Deer Creek Coal Mine North Rilda Canyon Portal Facilities

Ammendment to Update the Deer Creek Mining
and Reclamation Permit, Volume 11,
North Rilda Canyon Portal Facilities, PacifiCorp,
Deer Creek Mine, C/015/0018, Emery County, Utah

Revision June 2010

Subj: Amendment to Update the Deer Creek Mining and Reclamation Permit, Volume 11, North Rilda Rilda Canyon Portal Facilities, PacifiCorp, Deer Creek Mine, C/015/0018, Emery County, Utah.

Figures Section – Replace R645-301-500c

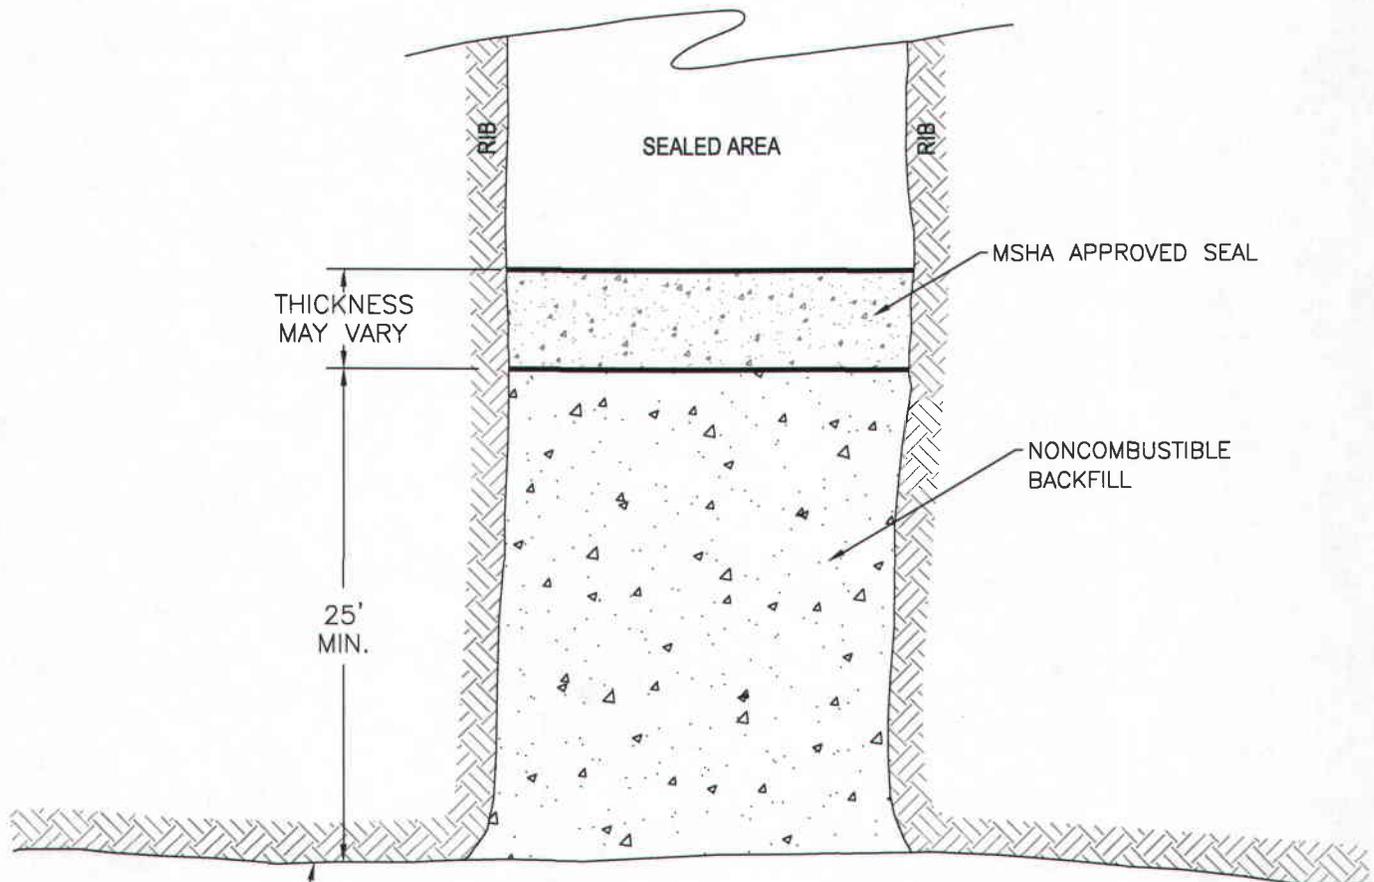
| <input type="checkbox"/> Add | <input checked="" type="checkbox"/> Replace | <input type="checkbox"/> Remove | DESCRIPTION |
|-------------------------------------|---|-------------------------------------|---|
| <input type="checkbox"/> | <input checked="" type="checkbox"/> | <input type="checkbox"/> | Volume 11, R645-301-500 Engineering Figures Tab, Replace Figure R645-301-500c |

| DRAWN BY: | <i>K. LARSEN</i> | <i>Figure R645-301-500d</i> |

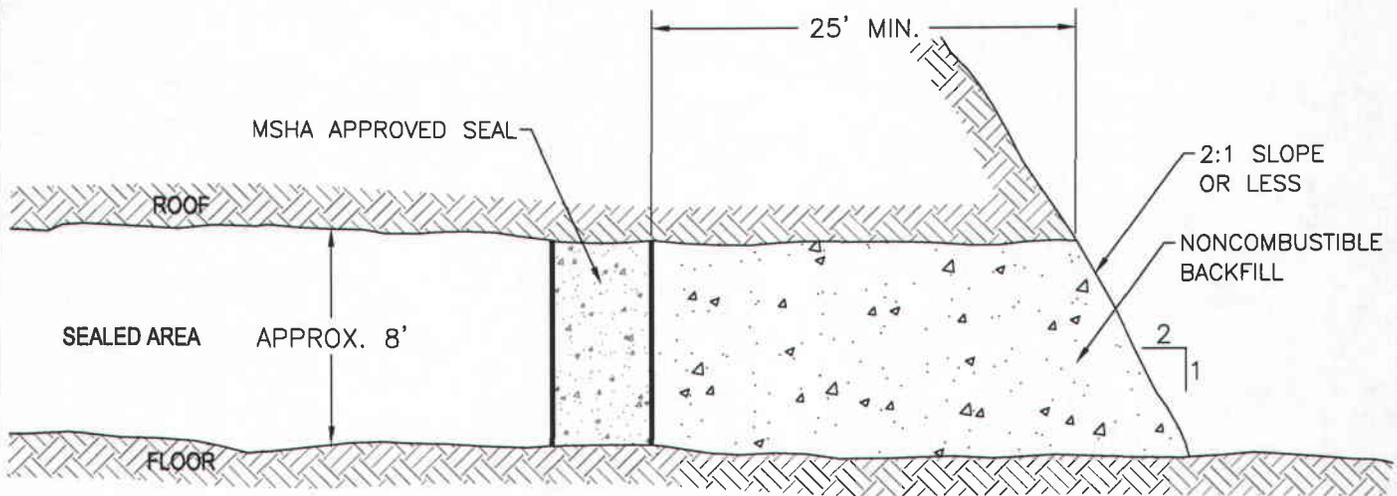
| <input type="checkbox"/> Add | <input checked="" type="checkbox"/> Replace | <input type="checkbox"/> Remove | DESCRIPTION |
|-------------------------------------|---|-------------------------------------|---|
| <input type="checkbox"/> | <input checked="" type="checkbox"/> | <input type="checkbox"/> | Volume 11, R645-301-500 Engineering Figures Tab, Replace Figure R645-301-500d |
